City of Albuquerque

HYDROLOGY SECTION
123 Central NW, Albuquerque, NM 87102
(505) 766-7644

RE: REVISED DRAINAGE PLAN FOR LOT 15 BALLOON FIELD INDUSTRIAL PARK
(E-17/D22H) ENGINEER'S REVISION BLOCK DATED DECEMBER 4, 1986

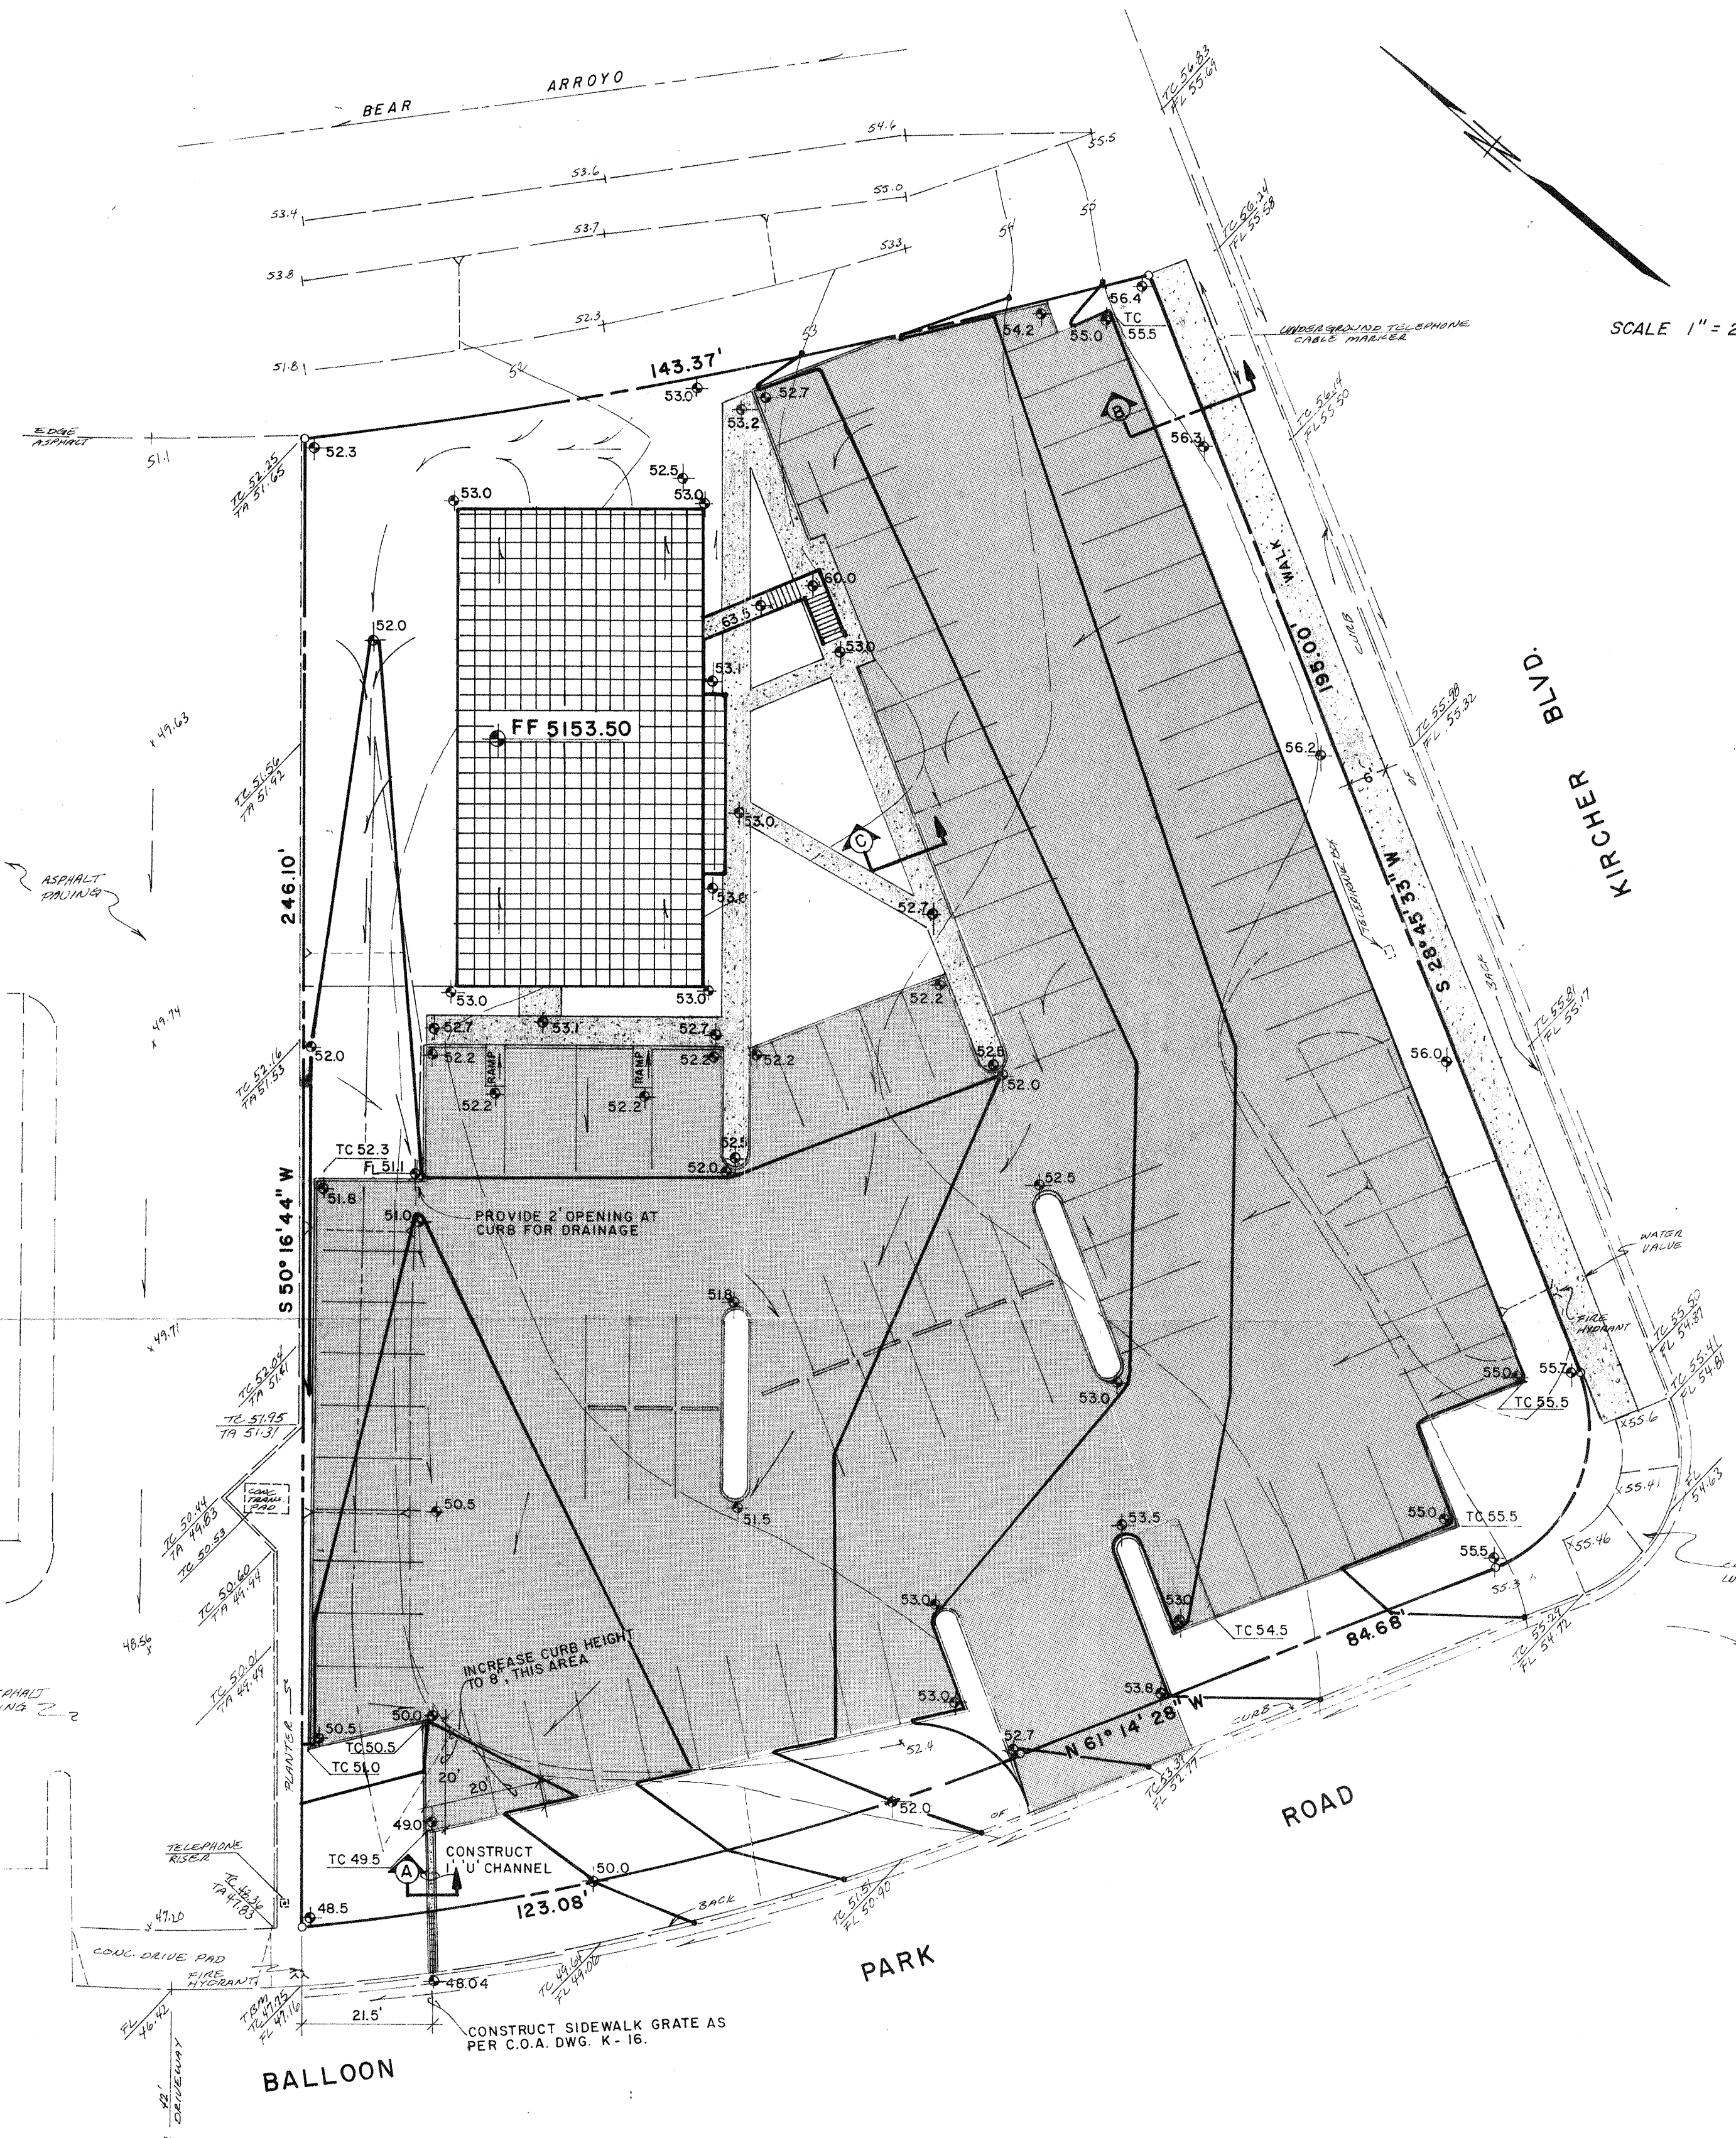
Based on the information provided on your resubmittal of December 5, 1986, the above referenced drainage plan is approved for Building Permit.

- CHANGED OUTLET CHANNEL DEPTH
- SHIFT DRIVEWAY 7' TO THE WEST
- CHANGED HANDICAP RAMP
- ADD ENTRANCE SOUTH SIDE BUILDING
- ADD STEPS/WALK NORTHEAST SIDE OF BUILDING
